Addendum No. 2

Project: The Brando for Bluestone Development

Date: 18 April 2013
From: Studio 951, Ltd.
To: All plan holders.

STRUCTURAL**S2.3**

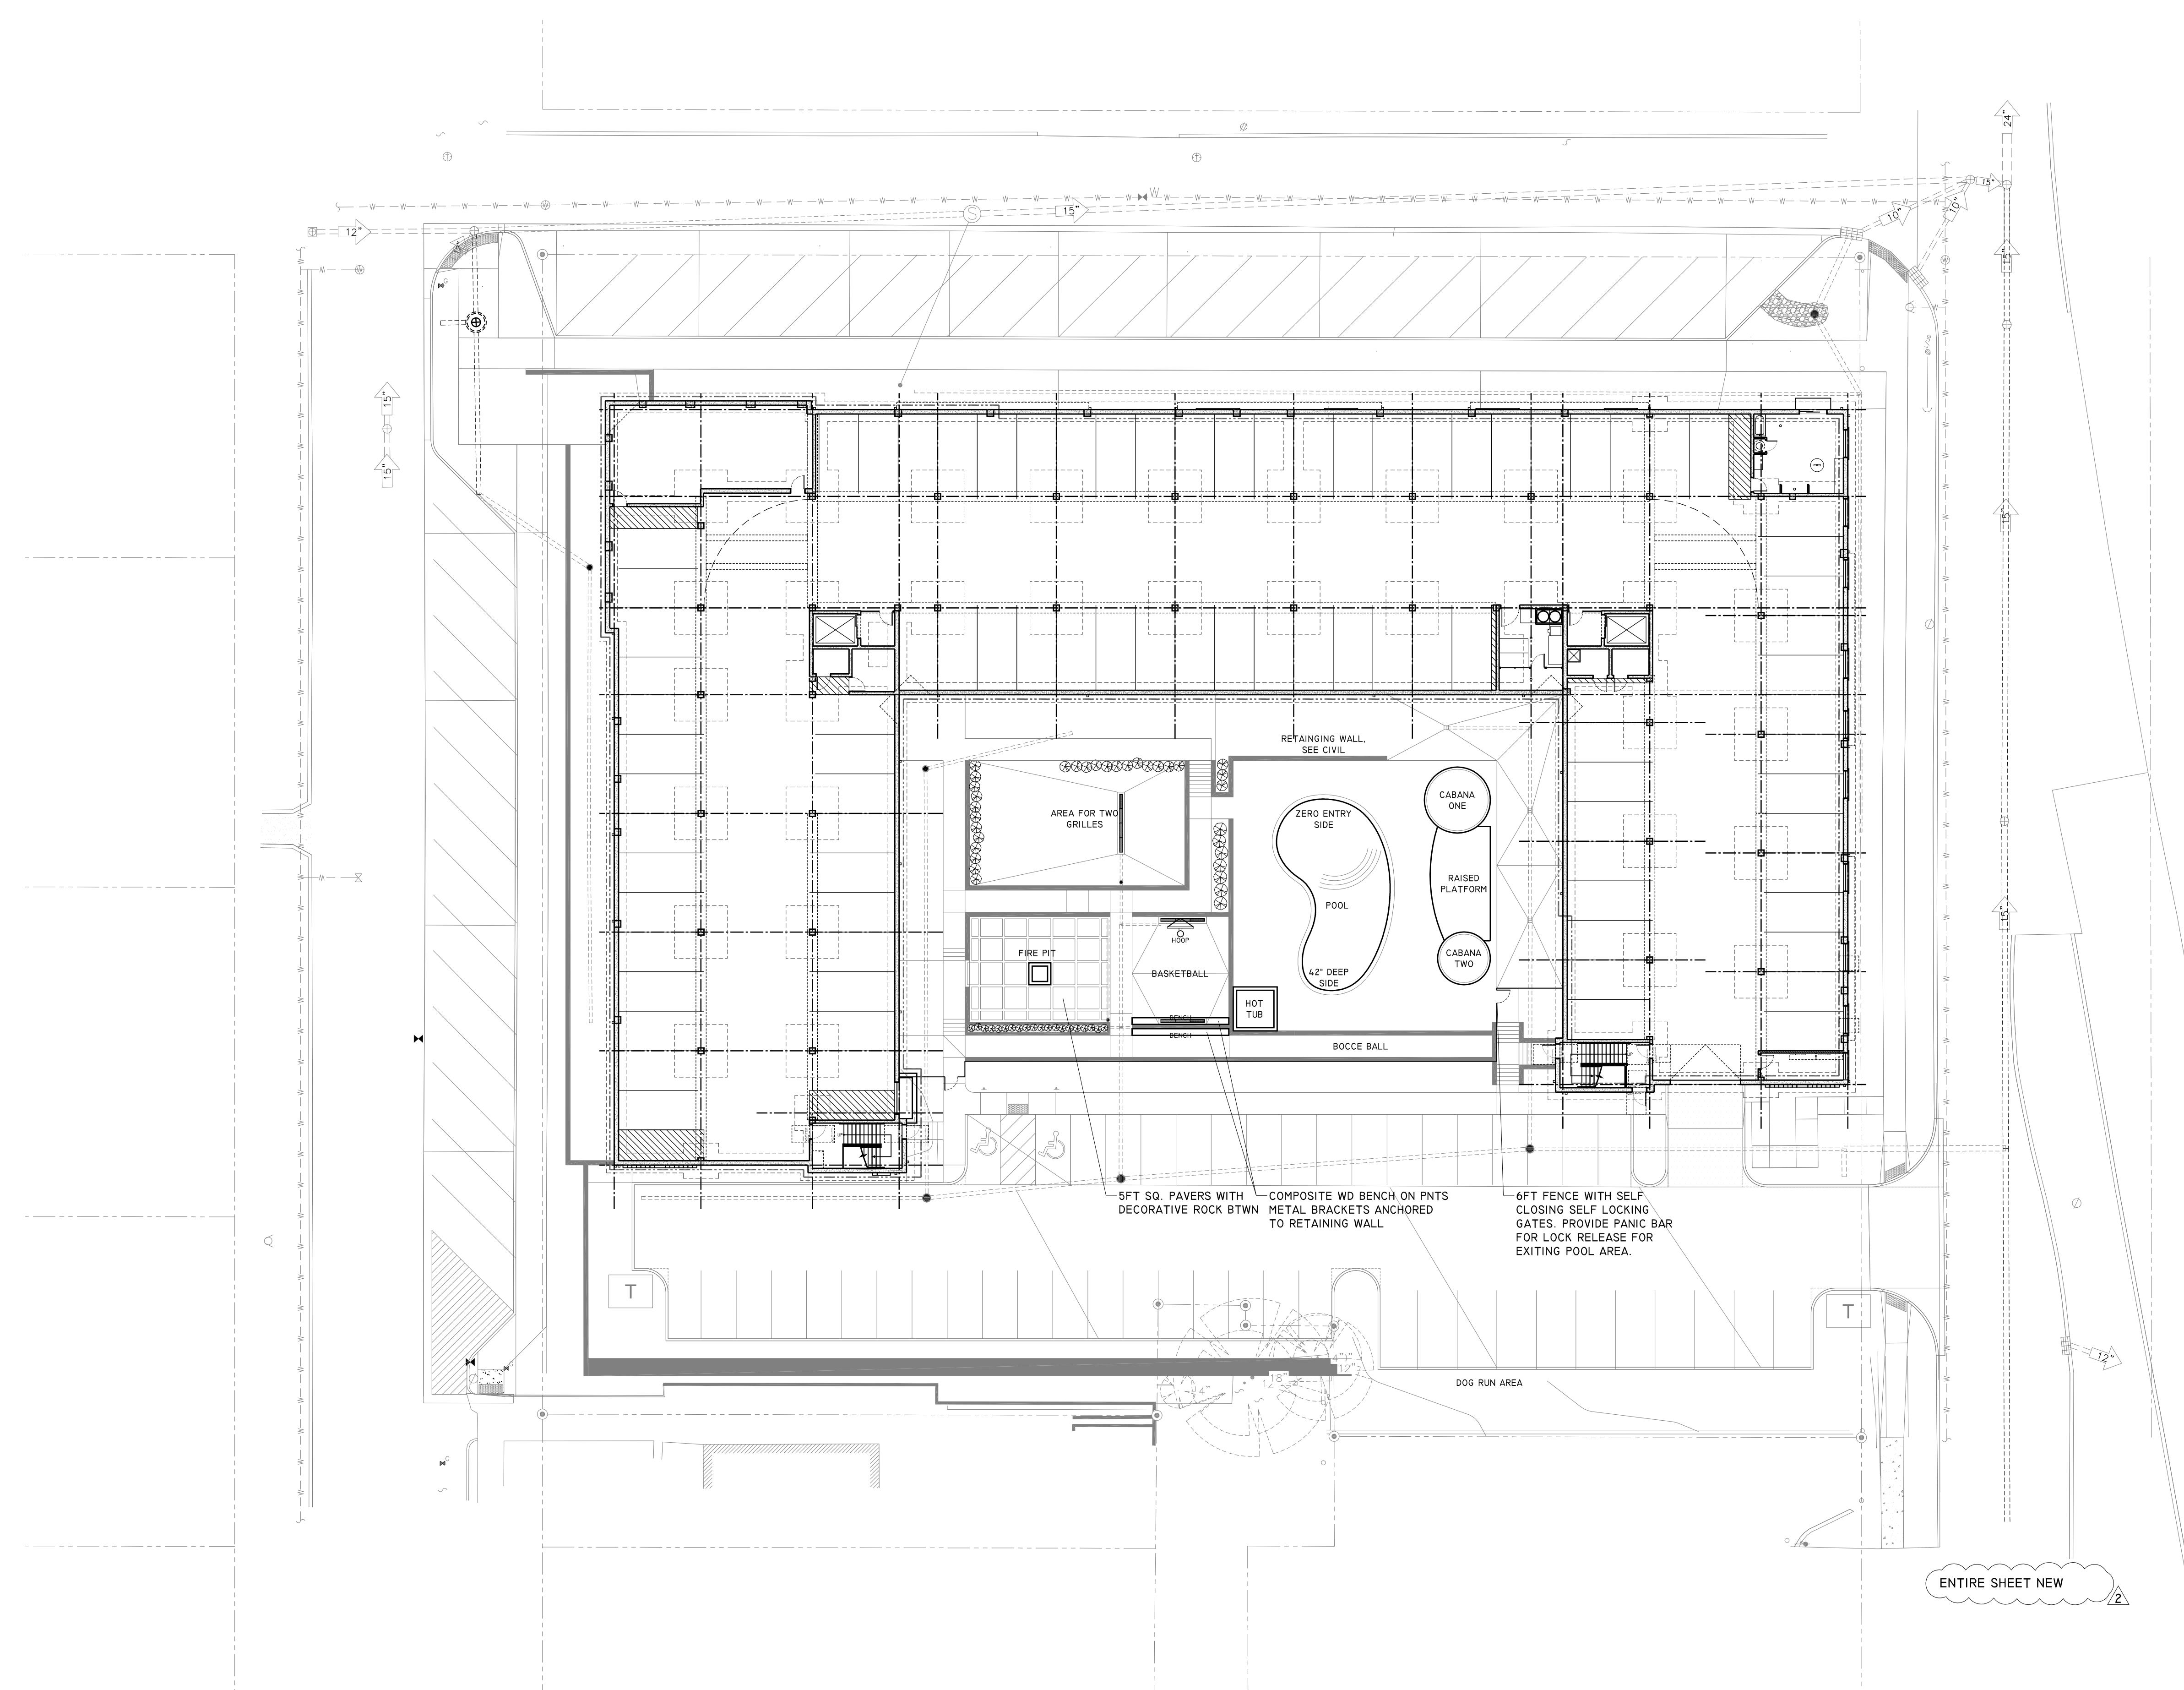
At the northwest corner of the building provide a new note to read, "Framing note: Contractor to supply (4) sets of (3) 1 ¾"X7 ¼" LVL stud framing at the northeast corner of the building for sign backing. LVL studs are to be ganged together with (3) 10D nails at 12" o.c. – two sets are required. Contractor to supply (16) Simpson HUC68 face mount hangers, (16) Simpson A35 framing anchors, and (16) Simpson MSTC28 strap ties."

N
X I
1" = 10'-0"
SECOND FLOOR PLAN

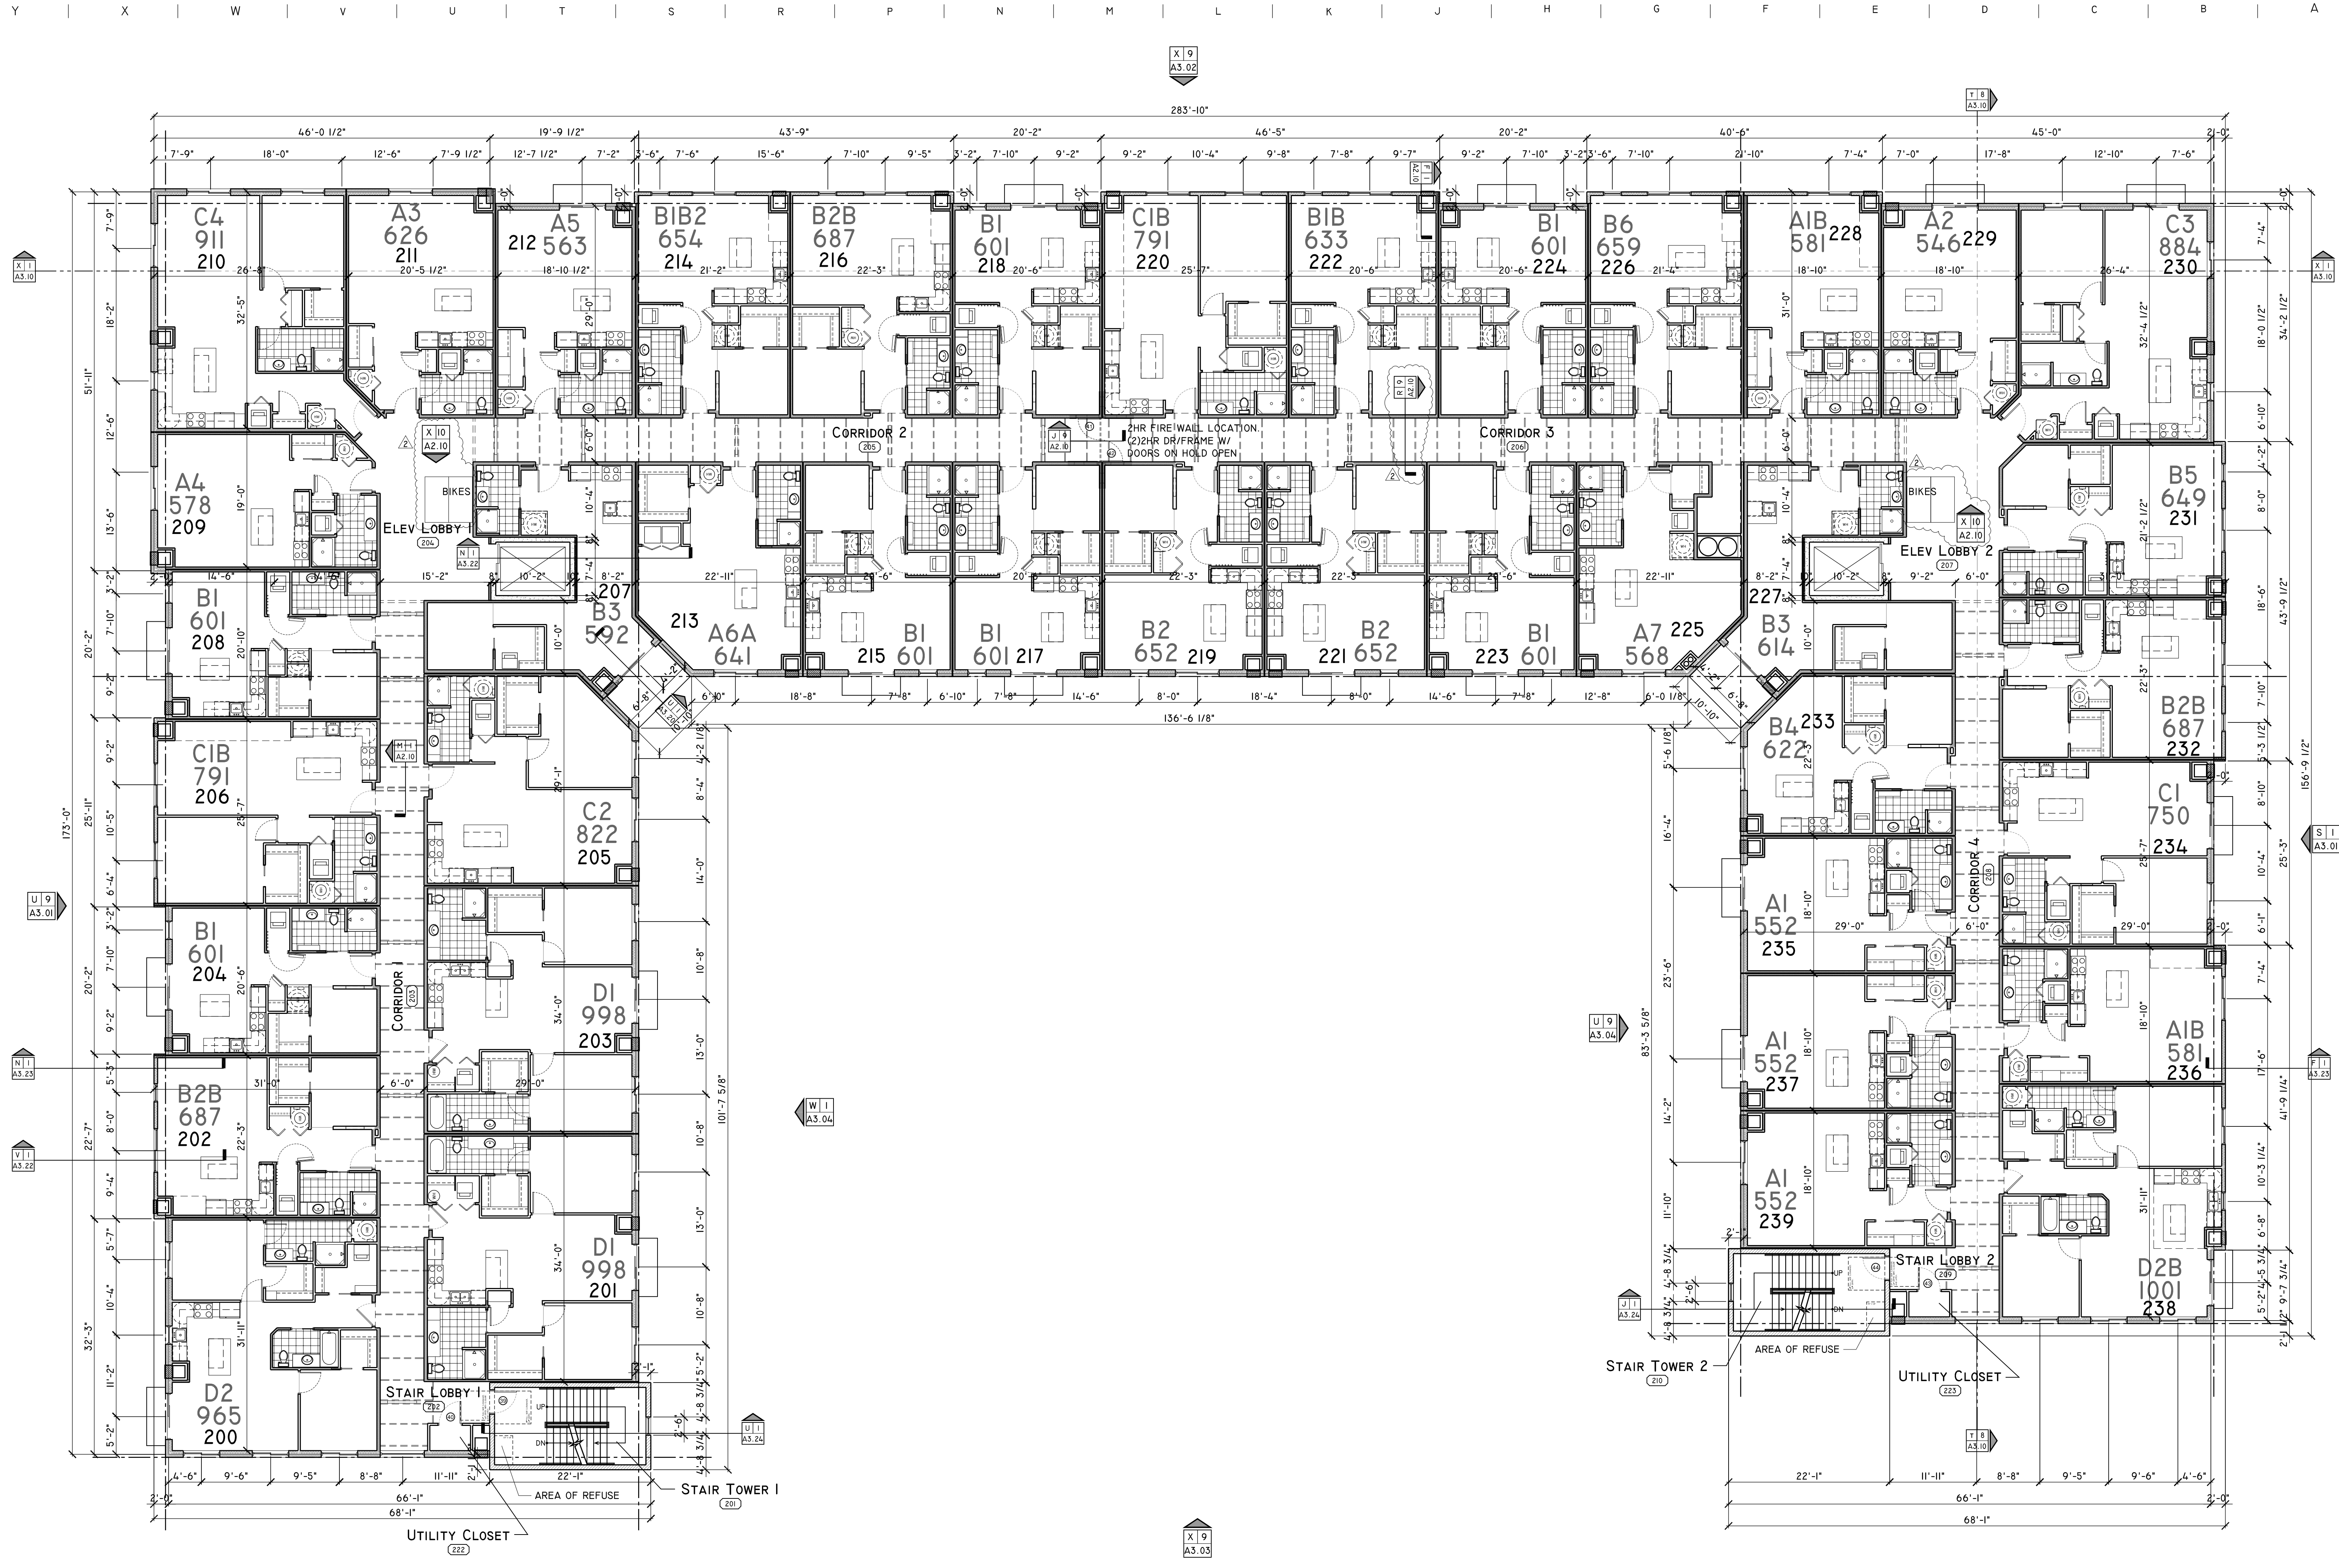
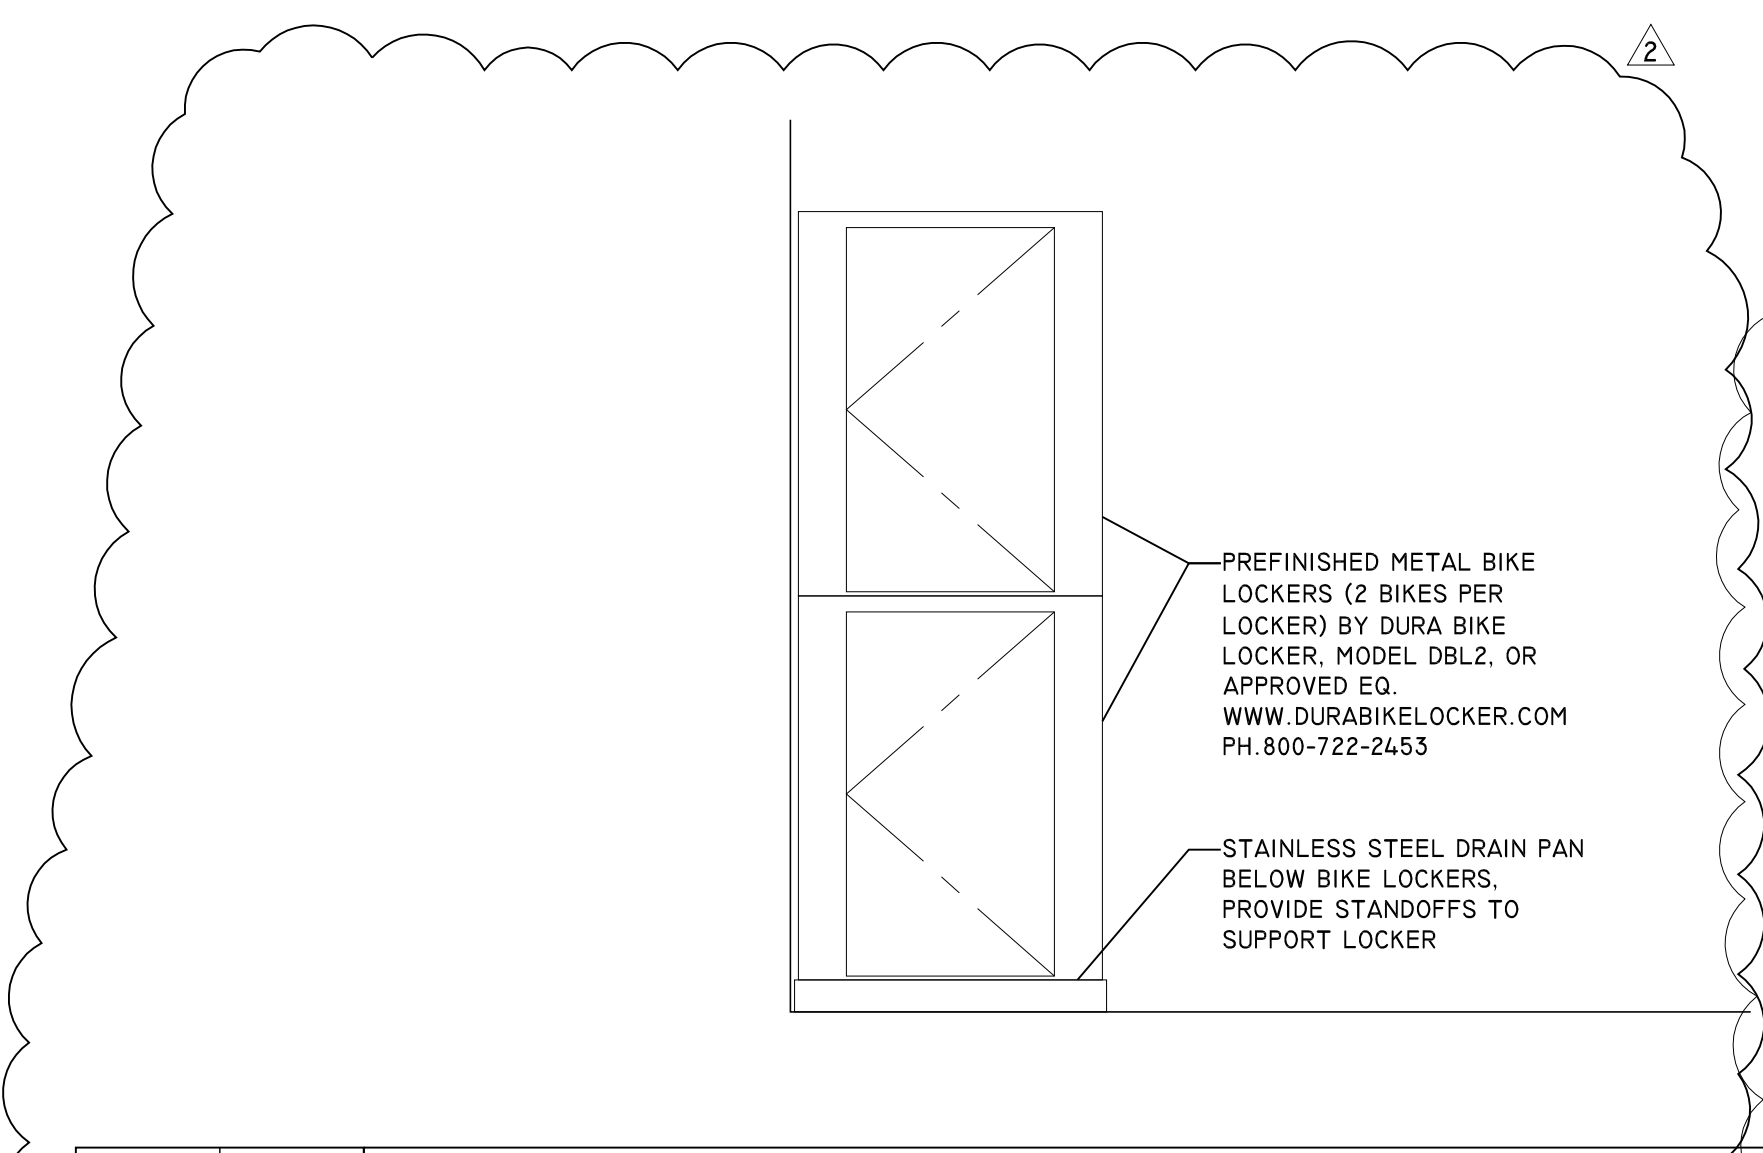
The new added note for, "PROVIDE ONE STANDPIPE ON EACH SIDE OF 2HR FIRE WALL AT CORRIDOR" applies to each residential floor.

The new added tag R9/A2.10 near sheet grid J-12 is a typical condition and applies to all residential corridors.
